Monday, August 22, 2022, 6:00 PM
Jarvis Hall 4505 N. Ocean Drive 33308

To: Planning & Zoning Board
From: Jhanelle Campbell, Development Services Director
Date: August 22, 2022
Re: Case Number 2022-L2-AA-02: David and Debra Cohen (the "Applicant") – Level 2 Administrative Adjustment Request to allow encroachments into the front and rear setbacks.

To: Planning & Zoning Board
From: Jhanelle Campbell, Development Services Director
Date: July 22, 2022
Meeting Date: August 22, 2022
Re: Case Number 2022-SP-01: 4245 N. Ocean, LLC ("Applicant") – Site Plan Approval Request for the development of a three-story 30-unit hotel (without kitchens)

Diagram 2

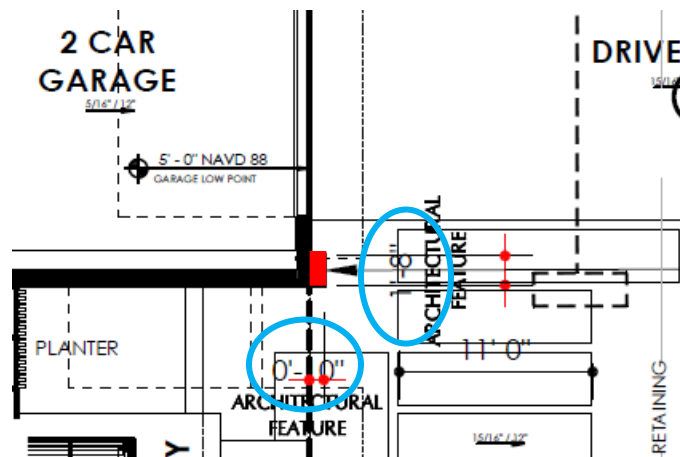
Diagram 2 depicts an architectural feature measuring one-foot-eight-inches (1'8") in width that encroaches ten (10) inches into the required front yard setback. **Diagram 3** depicts a second architectural feature measuring nine (9) feet in width that also encroaches ten (10) inches into the required front yard setback. In both diagrams, the portion of the proposed structure encroaching in the setback is shown in **red**.

Diagram 4

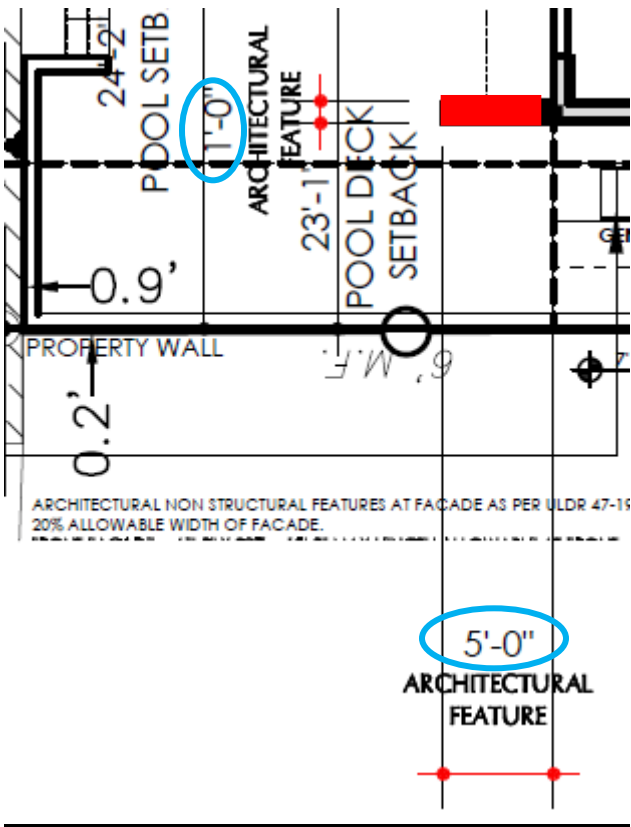
Diagram 4 portrays an architectural feature measuring one (1) foot in width that encroaches five (5) feet into the required rear setback.
